ADDENDUM

PROJECT: Jefferson Community Health Center
Cedarwood Assisted Living Addition
Fairbury, Nebraska

AD-2

DATE ISSUED: Wednesday, September 26, 2012

Drawing Title	
From Sheet:	for CA use:
A-101	
Drawing #	
A101.1

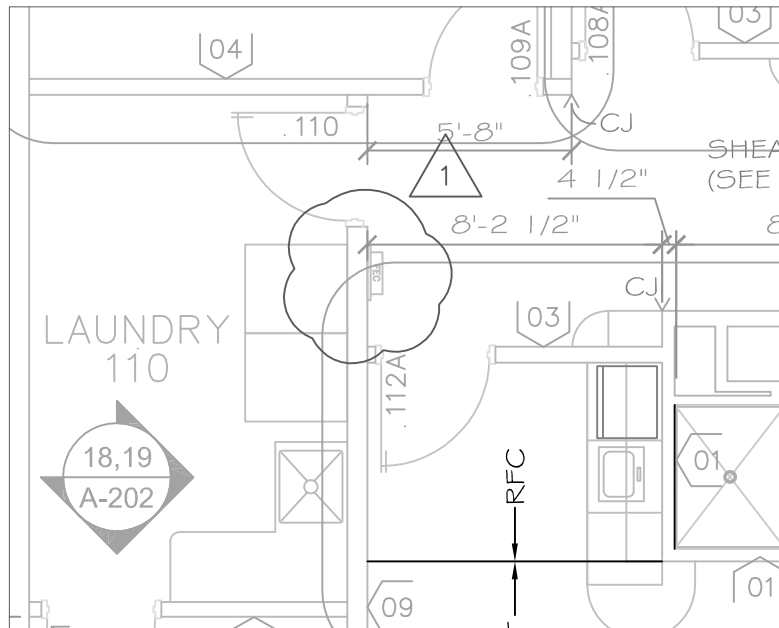
In reference to Sheet A-101, see attached partial plan for portable fire extinguisher locations.
